# Executive Director's Recommendation

| <b>PROJECT</b><br><b>US Park Police Stables Replacement and Site Improvements</b><br>Located in Ash Woods, between Independence Avenue and Ash Road, east of the Korean War Veterans Memorial and west of the DC War Memorial<br>Washington, DC | <b>NCPC FILE NUMBER</b><br>8014<br><br><b>NCPC MAP FILE NUMBER</b><br>1.43(38.00)44817<br><br><b>APPLICANT'S REQUEST</b><br>Approval of comments on concept design |
| <b>SUBMITTED BY</b><br>United States Department of the Interior<br>National Park Service  | <b>PROPOSED ACTION</b><br>Approve comments on concept design   |

OPT 1 - SYMMETRICAL BUILDING

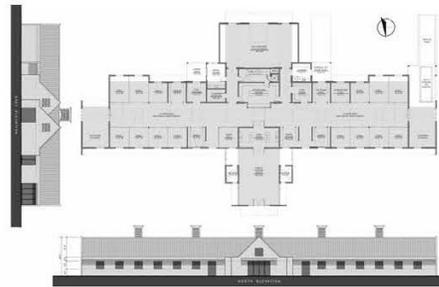
**Notes** that Alternative 1 proposes a traditional stable with a symmetrical composition, and a building orientation parallel to Ash Road and the Reflecting Pool. It includes a continuous pitched roof with five cupolas for ventilation. It also includes two public paddocks with viewing areas.

**Finds** that the symmetrical layout is efficient, elegant, and has a strong identity as a stable; however, the continuous roof line and cupolas make the building more visually prominent on the National Mall when compared to Alternative 2.

With regard to Option 1, staff finds that the symmetrical layout is efficient, elegant, and has a strong identity as a stable, however the continuous roof line and cupolas make the building more visually prominent on the National Mall when compared to Alternative 2.

OPT 2 - ASYMMETRICAL BUILDING

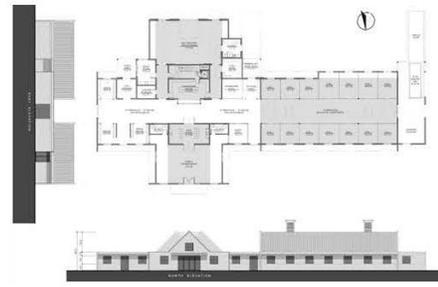
**Notes** that Alternative 2 proposes a contemporary stable with an asymmetrical composition, and a building orientation parallel to Ash Road and the Reflecting Pool. It includes a combination of pitched and flat roofs with two cupolas for ventilation. It also includes two public paddocks with viewing areas.

**Finds** that the asymmetrical design maintains the secondary character of the stables within the hierarchy of elements on the National Mall. The segmented roof line breaks the massing, provides opportunities for green roofs, minimizes the use of cupolas, and mimics the existing detached stables composition.

**Finds** that the proposed massing, scale, and height of the stables is compatible with the setting of the National Mall. It provides a compact and efficient layout that generates the least amount of impervious area, as compared to the other alternatives.

With regard to Option 2, staff finds that the asymmetrical design maintains the secondary character of the stables within the hierarchy of elements on the National Mall. The segmented roof line breaks the massing, provides opportunities for green roofs, minimizes the use of cupolas, and mimics the existing detached stables composition. Staff also finds that the proposed massing, scale, and height of the stables is compatible with the setting of the National Mall. It provides a compact and efficient layout that generates the least amount of impervious areas, as compared to the other alternatives.

OPT 4 - DETACHED BUILDING

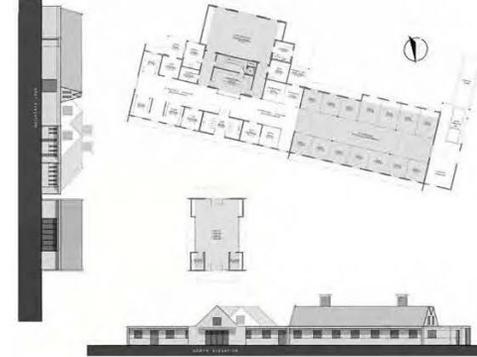
**Finds** that unlike Alternatives 1 and 2, Alternatives 3 and 4, should be dismissed because they follow the original orientation of the stables, rotated approximately 13 degrees away from Ash Road and the Reflecting Pool, and do not respond to the surrounding context.

Alternative 4 is similar to Alternative 3; however, Alternative 4 provides a detached pavilion for educational space, separated from the stables. Although the pavilion is parallel to Ash Road, it does not provide access from the National Mall. It generates the greatest amount of impervious areas, as compared to the other alternatives.
